SARGENTI ARCHITECTS, P.C.

RTM Engineering Consultants, LLC

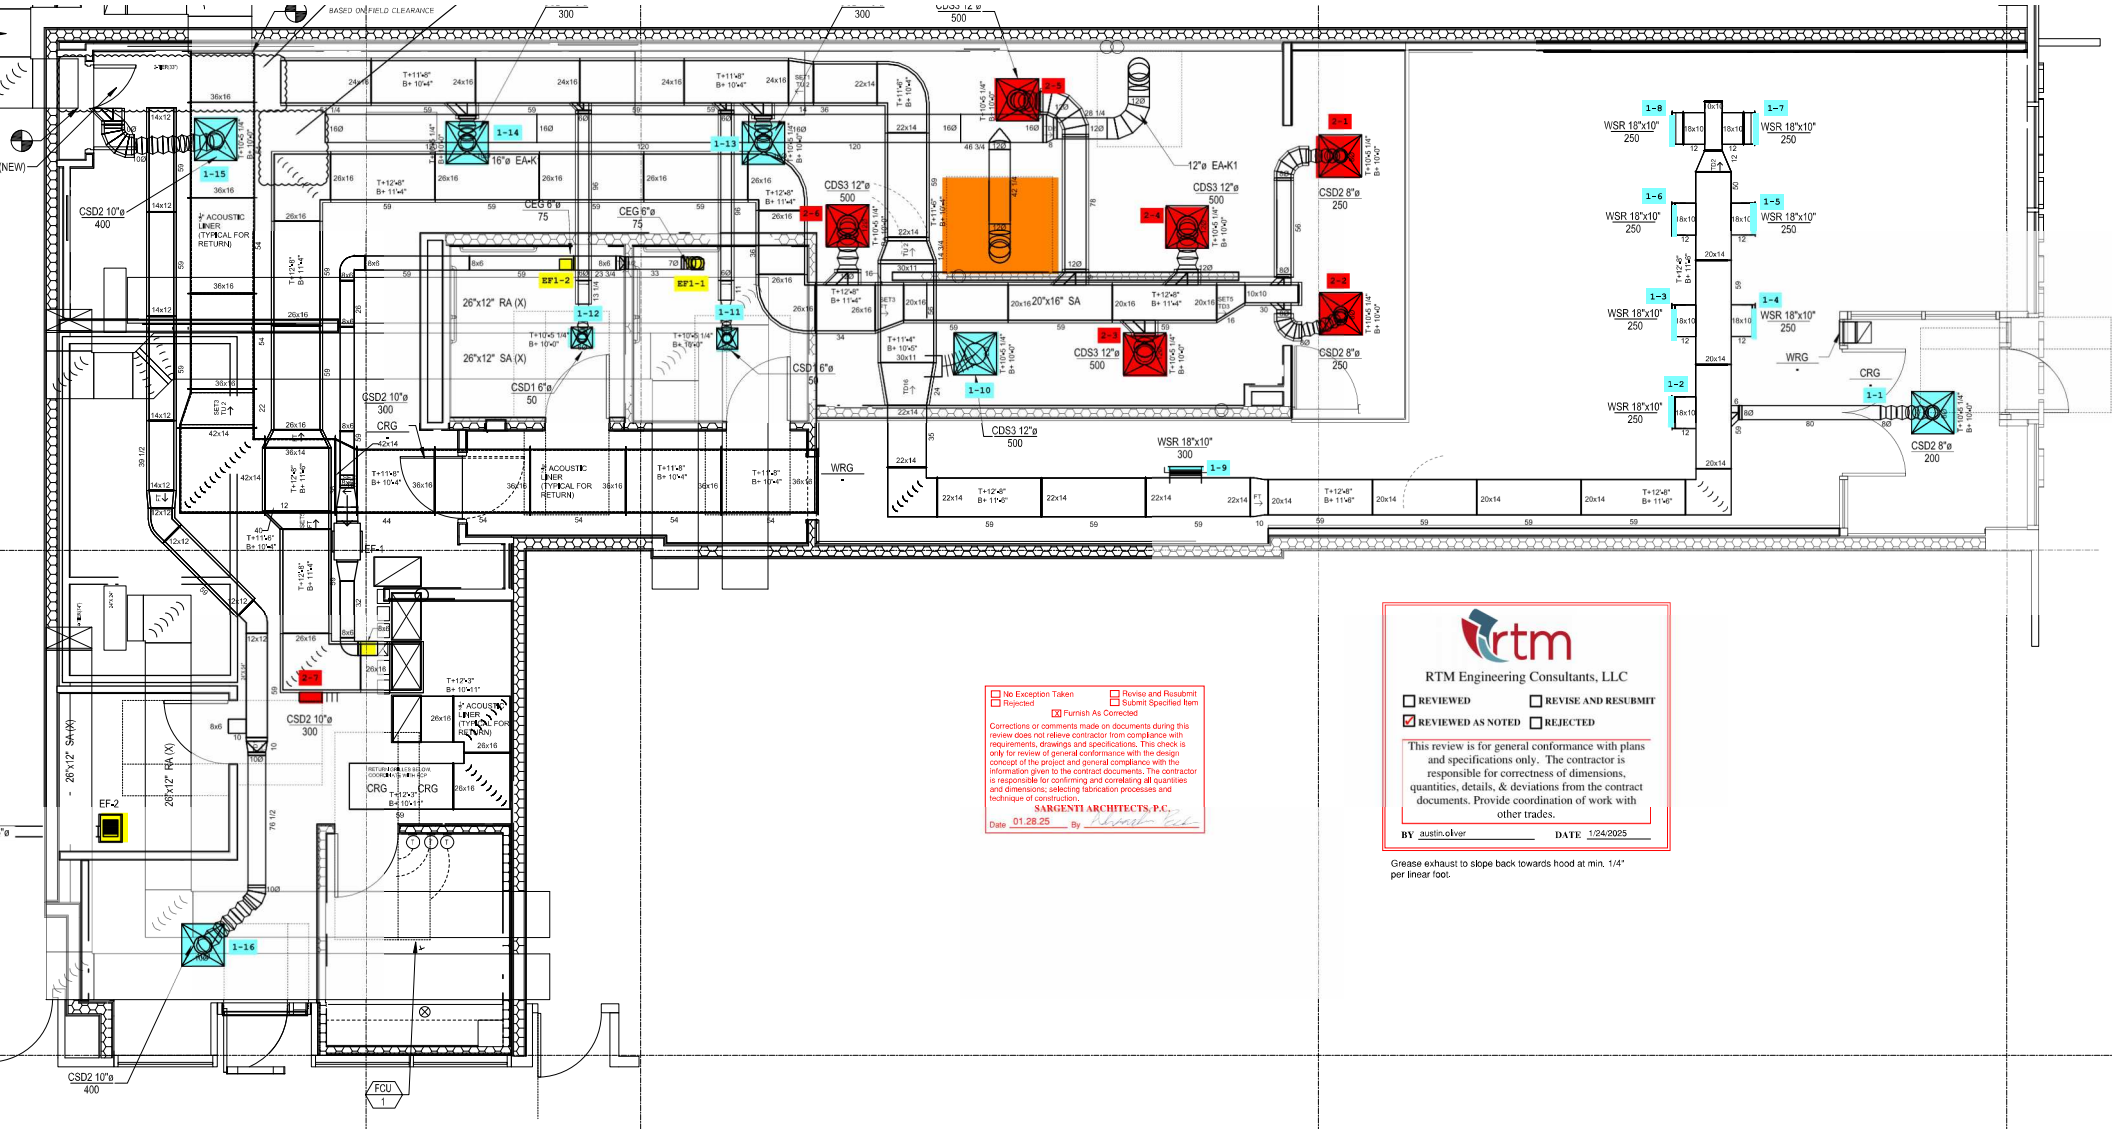
Grease exhaust to slope back towards hood at min. 1/4" per linear foot.
